2015SYE074 – Nos. 680, 682 & 684 Old Princes Highway, Sutherland

DA15/0462

ASSESSMENT REPORT APPENDICES

- Appendix A Draft Conditions of Consent
- B Pre-Application Discussion (PAD) letter
- C Public Submissions
- D Architectural Review Advisory Panel (ARAP) Reports
 dated 4 June 2015 and 20 November 2014
- E Applicant's SEPP1 Objections Building Height/ Building
 Density

BELMONT STREET ELEVATION (west)
Source: Innovative Architects **Figure 4: Western Elevation Extract – As proposed August 2015**

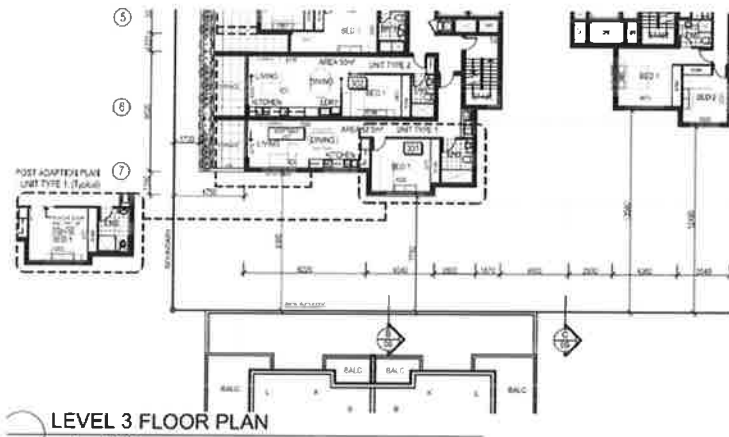
BELMONT STREET ELEVATION (west)
Source: Innovative Architects **Figure 3: Western Elevation Extract – As originally submitted**

Figure 5: Level 3 Plan Extract – As originally submitted

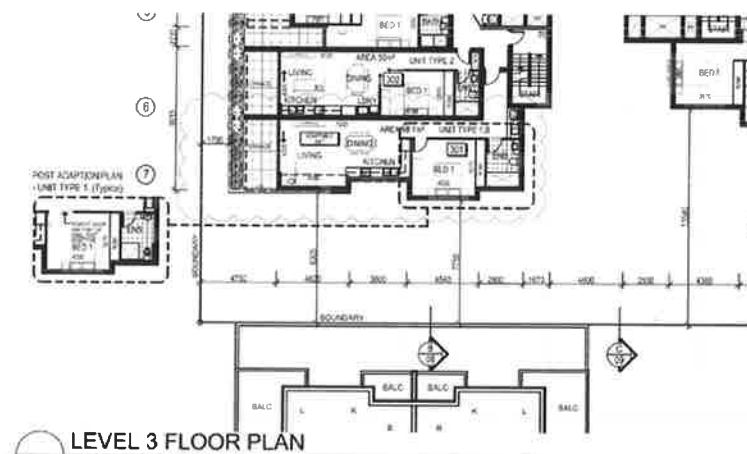
B: Living room width changes on levels 3 and 8

The following plans extracts shows the changes on level 3:
